SYDNEY CENTRAL CITY PLANNING PANEL

COUNCIL ASSESSMENT REPORT

Panel Reference	PPS-2019CCI013
DA Number	DA/85/2019
LGA	City of Parramatta Council
Proposed Development	Demolition of existing structures, tree removal and construction of a part two (2) part three (3) and part four (4) storey residential care facility (Seniors Housing) comprising of 120 beds with one level of basement car parking. The application will be determined by the Sydney Central City Planning Panel.
Street Address	Lot 1 DP 210512, Lot 16 DP 238510, Lot 6 DP 259726, 43-47 Murray Farm Road, No. 13 and No. 19 Watton Road, Carlingford, NSW 2118
Applicant & Owner	H B+B Property Pty Ltd
Date of DA lodgement	13 February 2019
Number of Submissions	Forty five (45) submissions
Recommendation	Refusal
Regionally Significant Development	Clause 2 of Schedule 7 of the State Environmental Planning Policy (State and Regional Development) 2011 as the development has a Capital Investment Value (CIV) in excess of \$30 million. The proposed development has a CIV of \$34,446,500

Report date	6 May 2020 (meeting date)

Figure 4: Proposed Site Plan. Source Thompson Adsett Architects

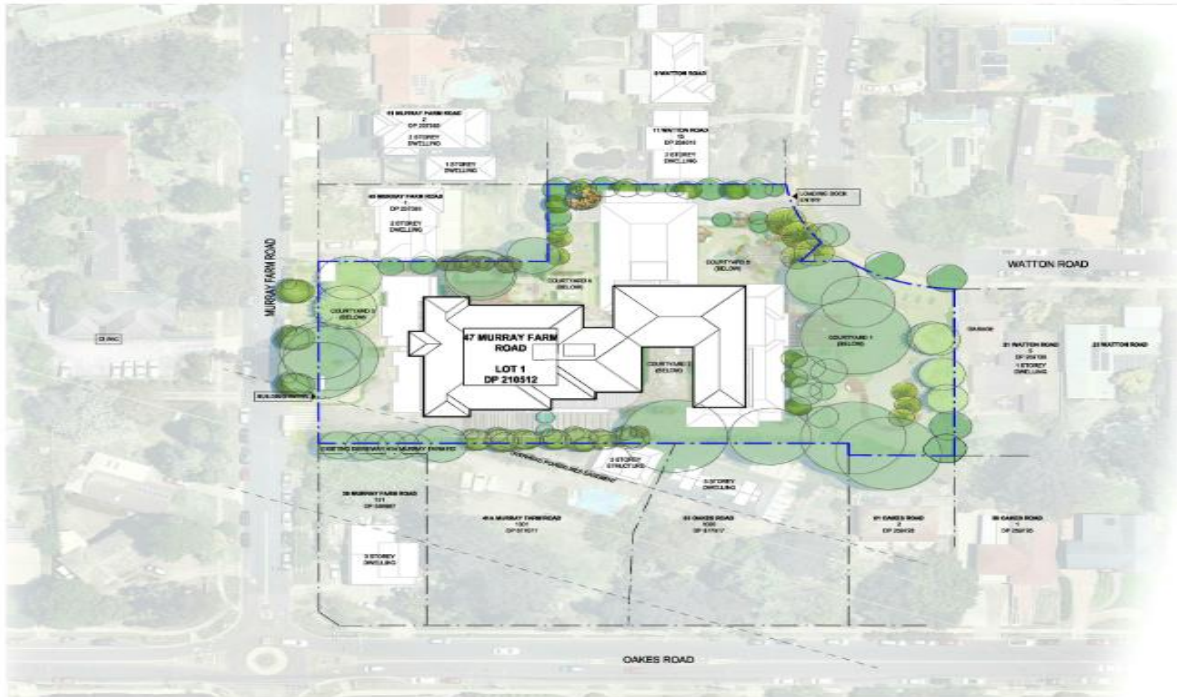
3. Incompatible bulk, scale and built form in the context of the area.

The proposed development predominantly presents as a part three and part four-built form, which is akin to a residential flat building, not suitable in this R2 low-density residential zone.

Figure 11: Council issued Flood Map showing 1% AEP flood extent

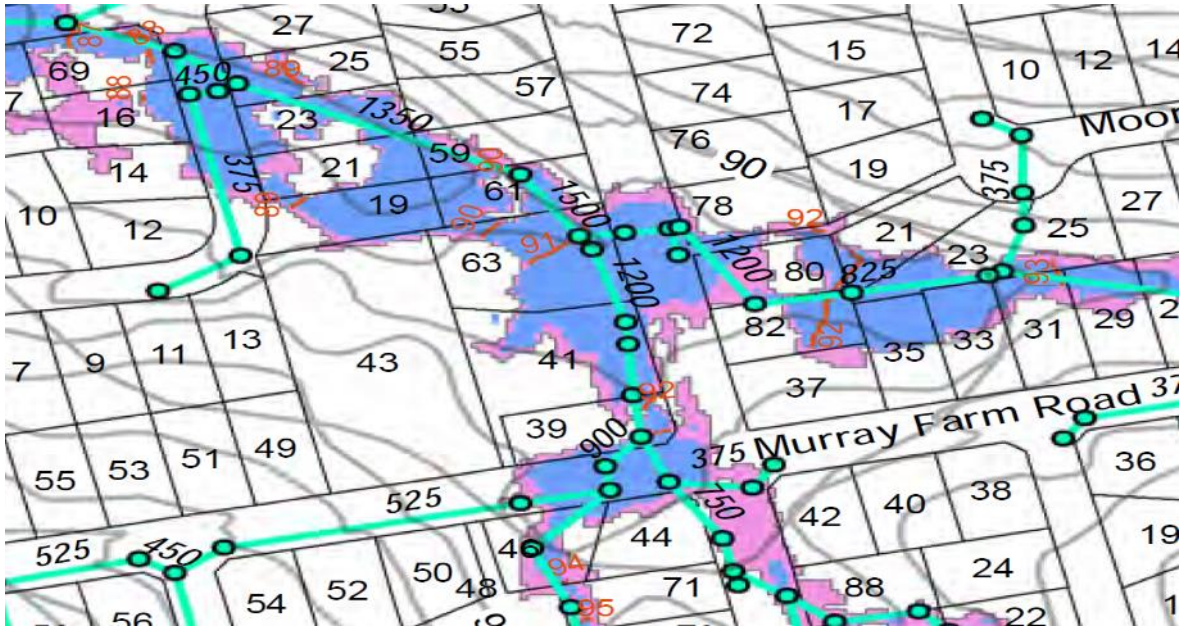
"The 1% AEP flooded area as shown below does not significantly impinge on No 43- 47 Murray Farm Road but substantially inundates the land at No. 19 Watton Road, Carlingford.

The application has responded to this in the design of the building footprint which avoids the No. 19 Watton Road.

Figure 13- ELF magnetic field contours from source to the building

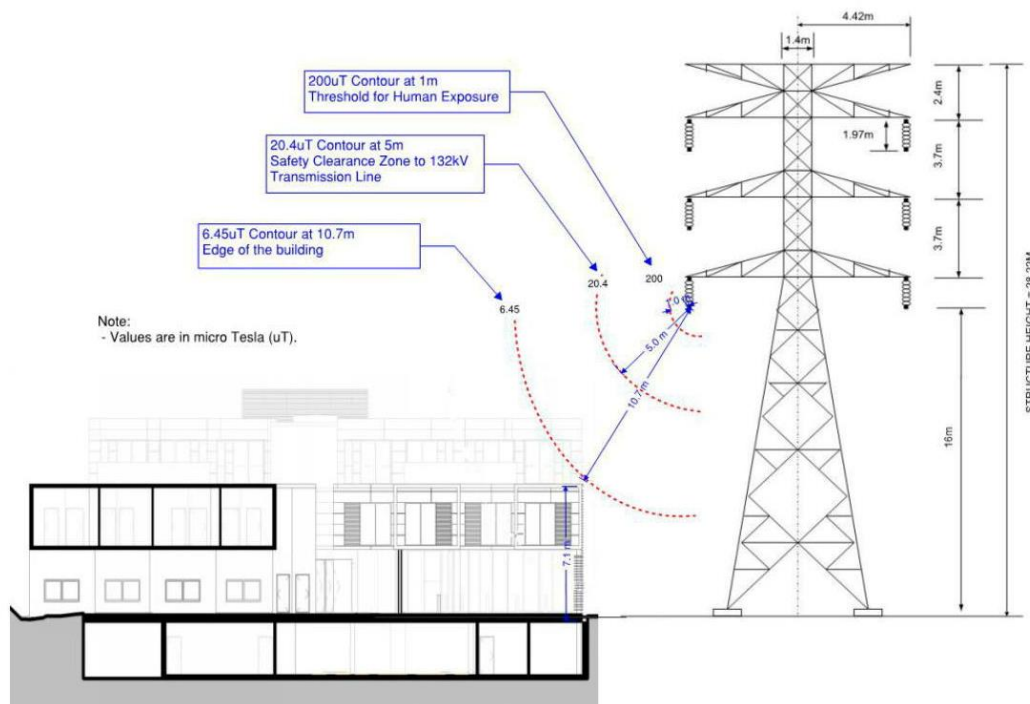
- *The calculated ELF magnetic field at this site is well within the threshold for human exposure in the general public of 2,000mG. This limit has been calculated at a distance of 1m from the transmission line as shown in figure below.*

- The installation of local ELF magnetic field shielding is not required with fields to adjacent spaces naturally already below the acceptable threshold.
- Minimum safety clearance between structure and transmission line must be 5m based on AS 7000- 2016 'Overhead Line Design'. Considering this as the worst case scenario, ELF magnetic field density at 5m is calculated to be 204mG, as shown in figure above, which is far less than the maximum threshold for general public exposure.
- Site survey along with section view of the building clarifies that the closest point of the building to the transmission line is 10.7m. ELF magnetic field density at this point is calculated to be 64.5mG, as shown in figure above, which is far less than the maximum threshold for general public exposure.
